CZ Cartage, JSP13-70

Public hearing at the request of CZ Trucking Realty, LLC for Preliminary Site Plan, Wetland Permit, Woodland Permit and Stormwater Management Plan approval. The subject property is located in Section 17, south of Grand River Avenue and east of Wixom Road in the I-1, Light Industrial District. The subject property is 17.78 acres and the applicant is proposing to construct a parking area for 72 trailer trucks.

PLAN REVIEW CENTER REPORT

PLAN REVIEW CENTER REPORT

PRELIMINARY SITE PLAN

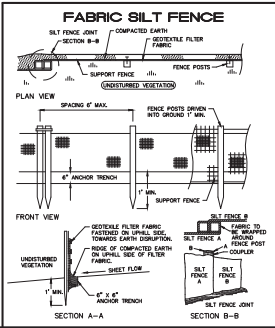
VARIANCES WILL BE REQUESTED FOR NON HARD SURFACE PAVING AND DELETION OF CURBS.

6. Revise the plan set to provide a minimum of three inches of asphalt over eight inches of aggregate base and curbing around the parking lot perimeter or provide a **Design and Construction Standards variance from Section 11-239(b)** for lack of pavement and curbing around a parking lot.

Table 10-4. Loading Space Dimensions

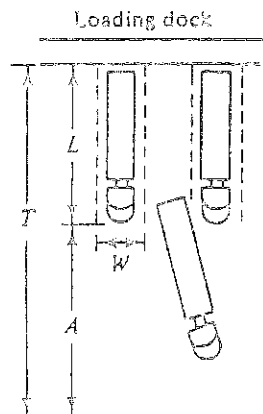
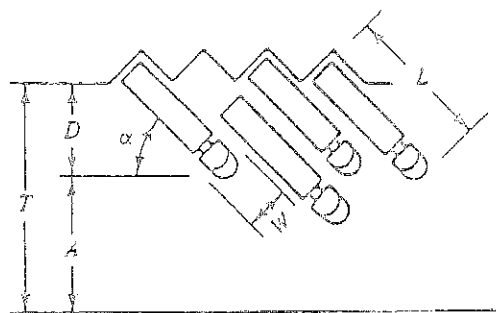
7. **The applicant should provide more information about the sizes of trailers expecting to be parked (e.g., typical numbers of WB-50s, WB-62s, etc.).** We have attached the associated loading space dimensions recommended by the Institute of Transportation Engineers.

CZ Cartage is a local trucking company with all company drivers, serving lower Michigan, hauling general commodities for the past 30 years. We use 48 foot and 53 foot commercial trailers, utilizing 90 degree docking and parking. The articulating vehicles turn around in 63 feet. Our existing trailer to curb is 66 feet. Our intention is to combine these adjoining property parcels. We are expanding by adding approximately 70 trailer spaces for overnight parking for our day time deliveries. New lighting is to be added for dusk to dawn service for compliance with existing yard lighting, for nighttime movement between yard and docks for loading and unloading operations. Note that 70% of trailers moved in and out are moved with a mechanical, single axle professional Yard Switcher truck after dusk. 20% are moved with full time, CDL-A company drivers in the AM and returned in the PM. The new parking area plan was defined with 80 foot between the two rows of trailer parking. Whereas only 63 feet is our requirement to spin and back up and park our trailers precisely. Also intended was to epoxy paint lines between trailers for structured parking, matching our existing parking area. This parking extension is to reduce a bulging existing parking area and redefine snow pile accumulations in heavy snow years.

Attachments:
Aerial photo
ITE-recommended loading space dimensions
CZ mark-up of PSP

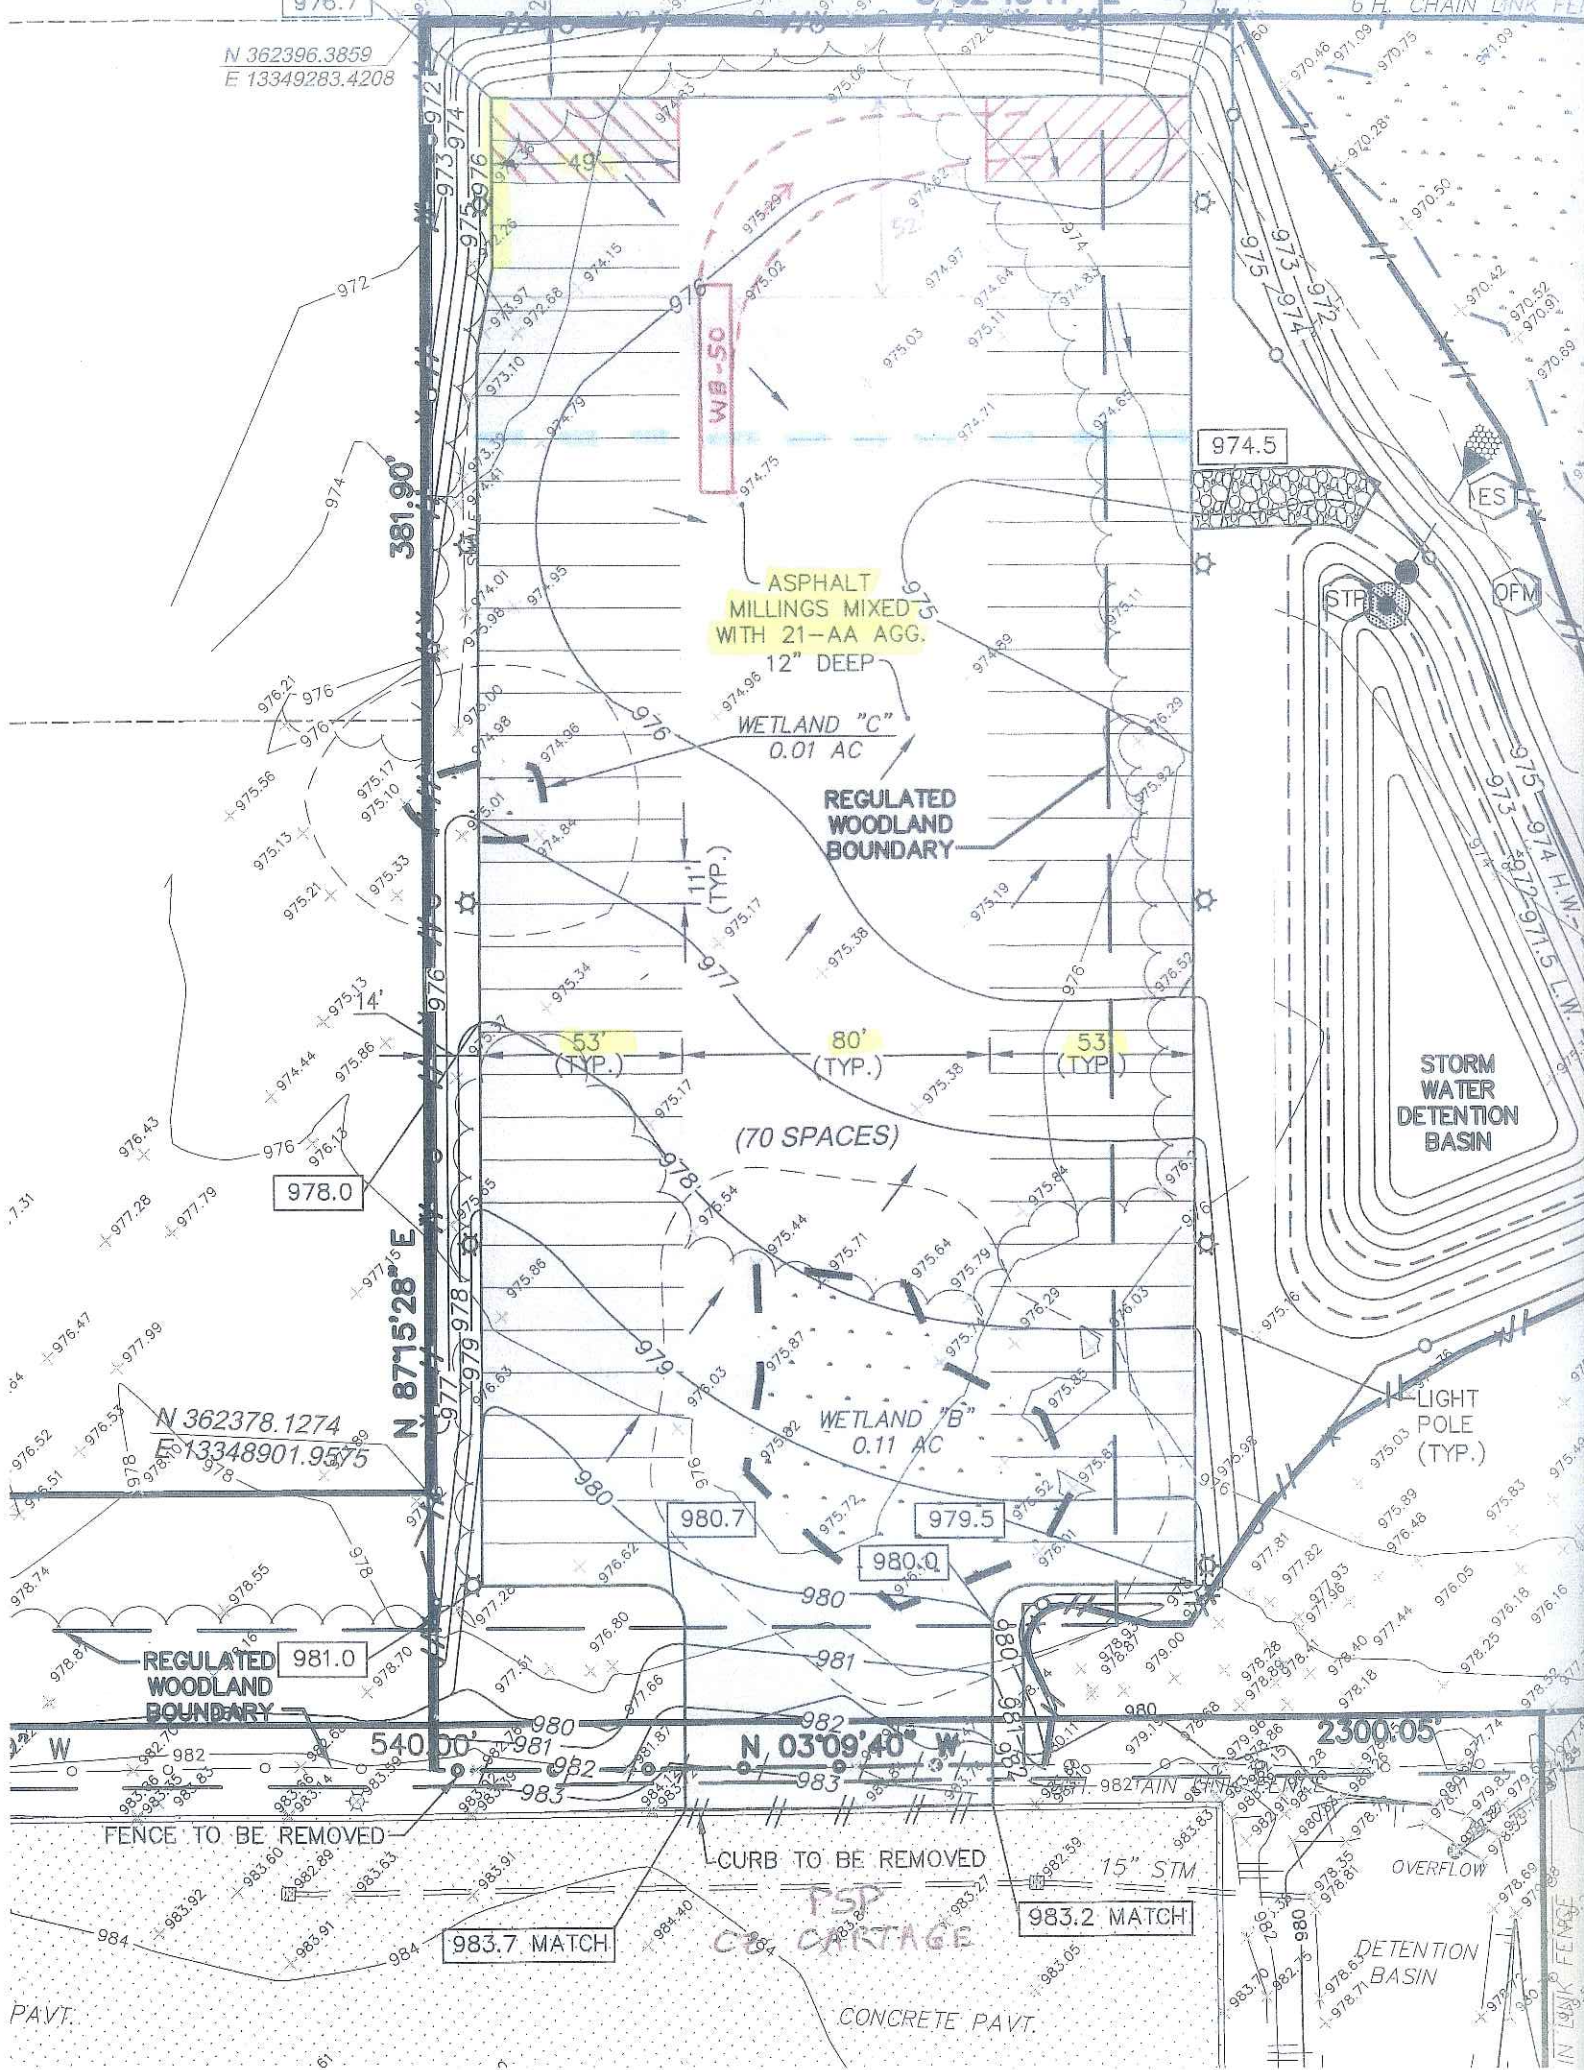
9. To deposit a trailer in one of the easternmost 16 parking spaces (eight on either side of the lot), a tractor-trailer (or spotter-trailer) would have to turn around on the existing site and back several hundred feet through the lot. In our opinion, this would be unsafe and as well as inefficient. As we recommended previously, **the four easternmost parking spaces (two on either side of the lot) should be kept open – preferably via crosshatching as well as signage – to provide a turnaround space for a truck to pull into prior to backing into one of the above-cited 16 parking spaces** (e.g., to deposit a trailer in one of these spaces along the north side of

the lot, the rig would first pull into the turnaround space in the southeast corner of the lot).
This would significantly reduce the required backing distances, thereby improving parking lot safety and efficiency. (See our mark-up of the site plan, attached.)

3. The City Fire Marshall has responded to the site plan. See his letter. A gate is shown, but not called out. A gate will be provided.
4. The driveway is shown in its entirety on sheets 1 and 2.
6. Traffic operational information has been provided by the applicant and is attached.
7. The trailer size is provided by the applicant on the attached letter.
8. The surface marking of the spaces is indicated by the applicant on the attached letter. A variance will be requested for the hard surfacing and curbing.
9. The four easternmost spaces will be deleted for parking and will be used for turnaround.
